Addendum to H-60-09-ASAM-04 / UH-1-09-ASAM-01  
**MK44 MOD 0 Cartridge Activation Device**

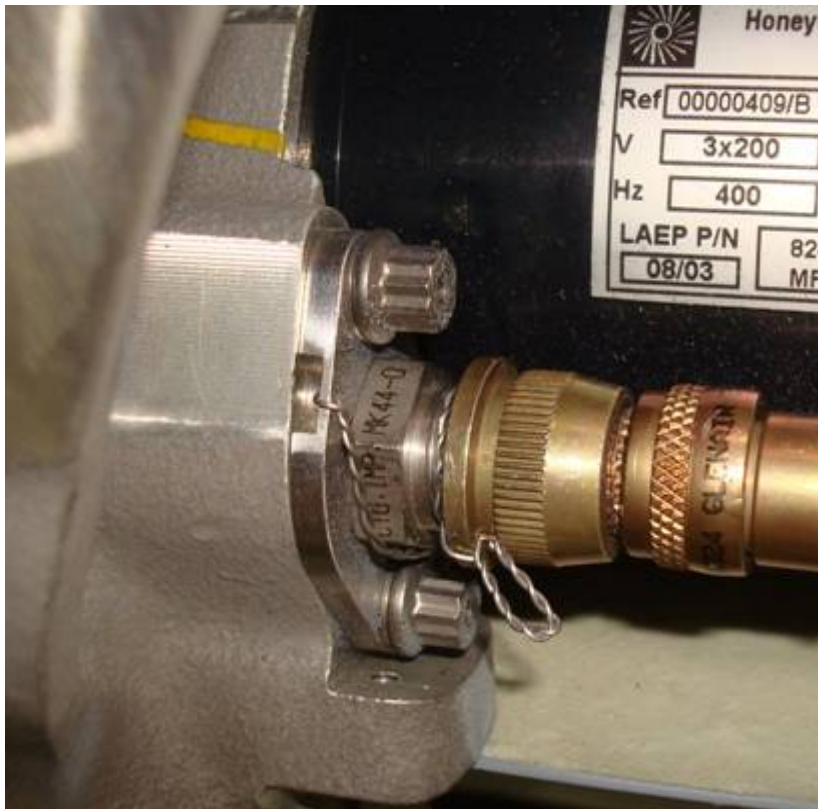
**CORRECT INSTALLATION**

**BRASS COLLAR REMOVED**

**INCORRECT INSTALLATION**

**BRASS COLLAR INSTALLED**
